NORTH ANNA COL

**DOCUMENTATION OF TECHNICAL REVIEW
SUBCONTRACTOR WORK PRODUCT**

REPORT : Summary Sheet, Rev 2 only to be inserted in Rev. 1 CPT Site Investigation, North Anna COL, Gregg Project No. 06-101SC

SUMMARY OF REVISIONS REV. 2 CPT REPORT (table 1 only revised and issued)

Site: NORTH ANNA COL.
Location: CPT-907 1

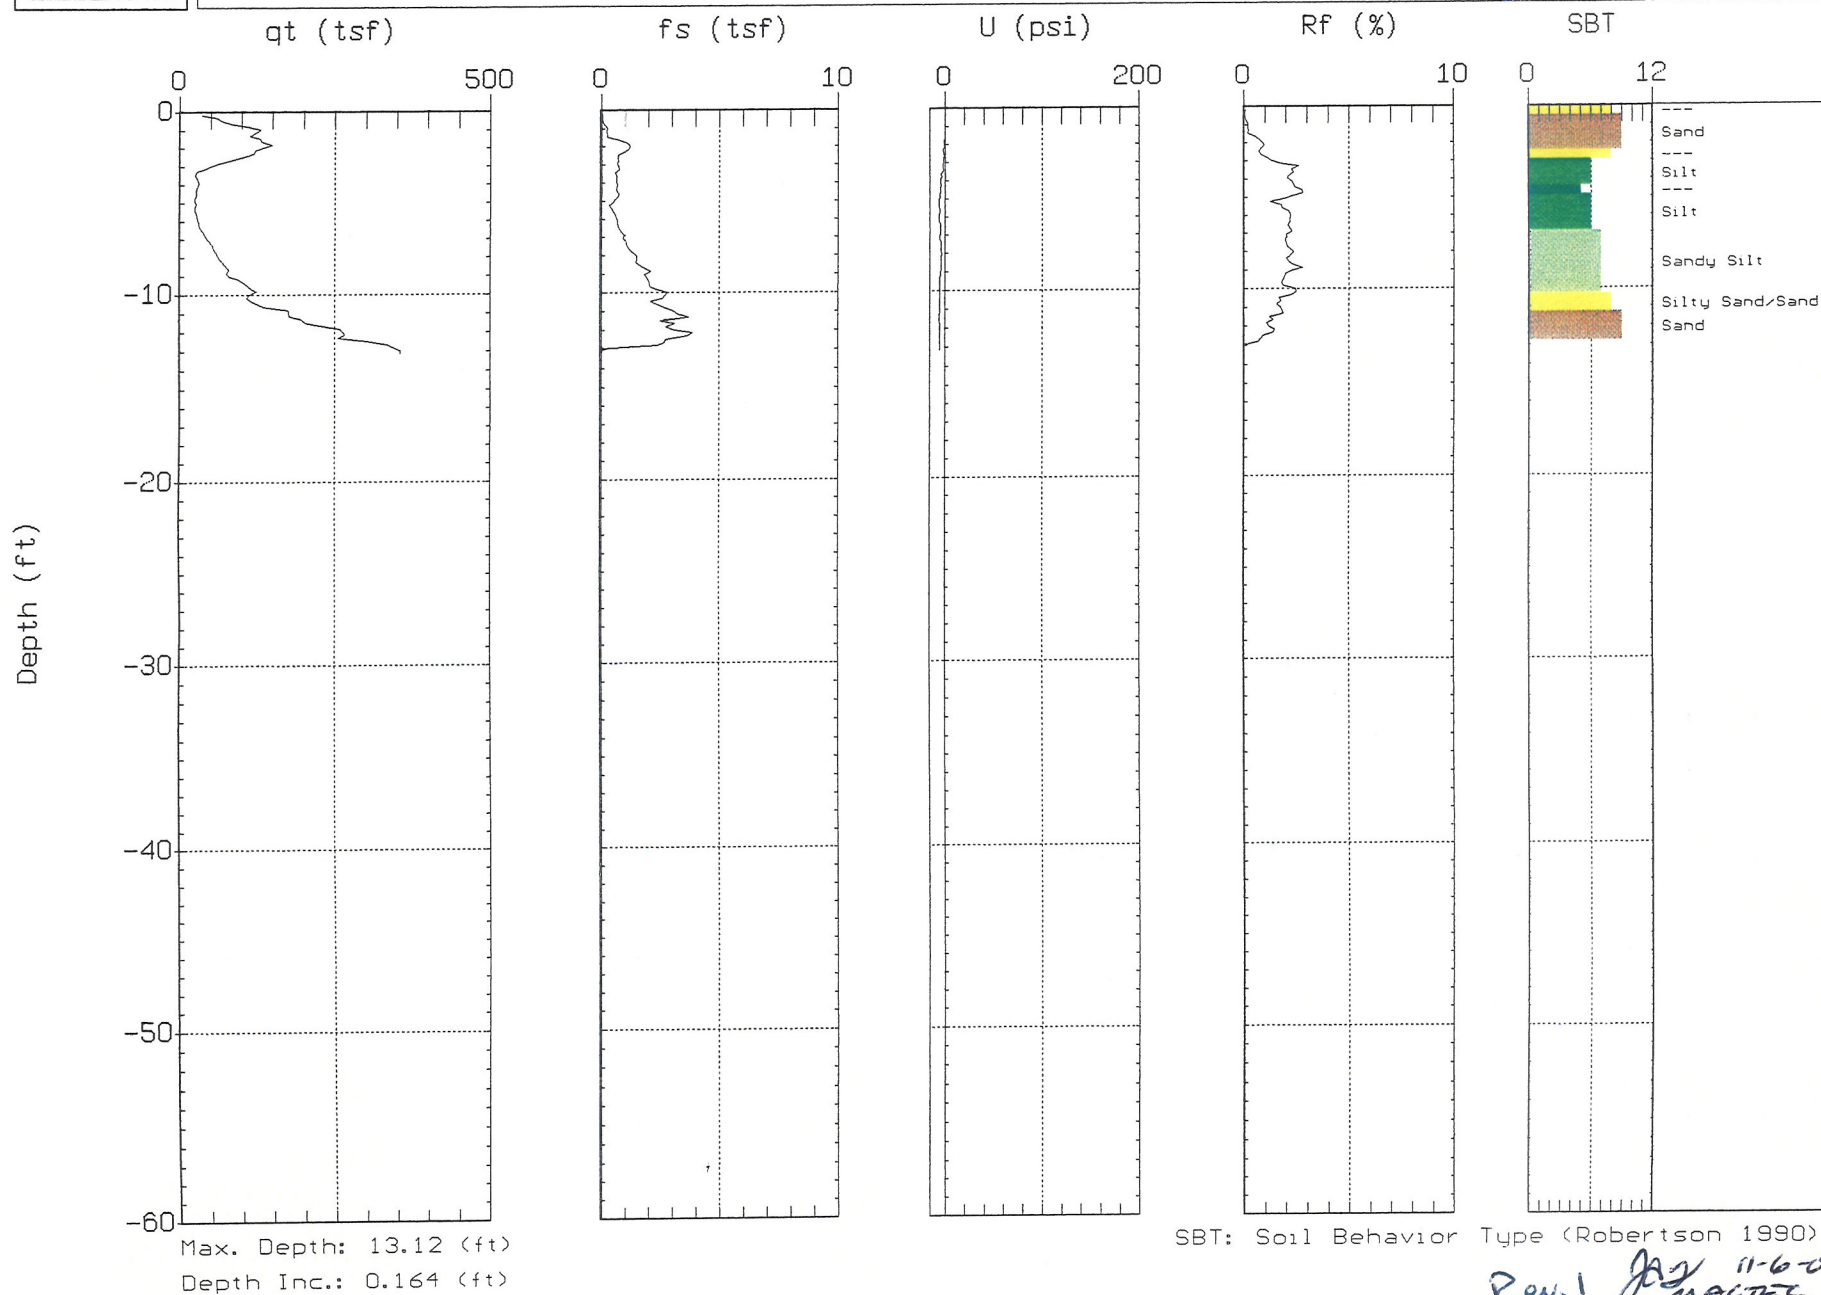
1. Cone Penetration Test Sounding Summary – Table 1. Replaced table to correct mis-numbering of CPT-907 and CPT-917.
2. Plots for correct CPT-907 inserted. No plots for CPT-907 were included in the original report.
3. Replaced plots for CPT-917 with correct plots.
4. Removed plot of Pore Pressure Dissipation Test labeled CPT-907 and replaced with plot correctly labeled CPT-917.
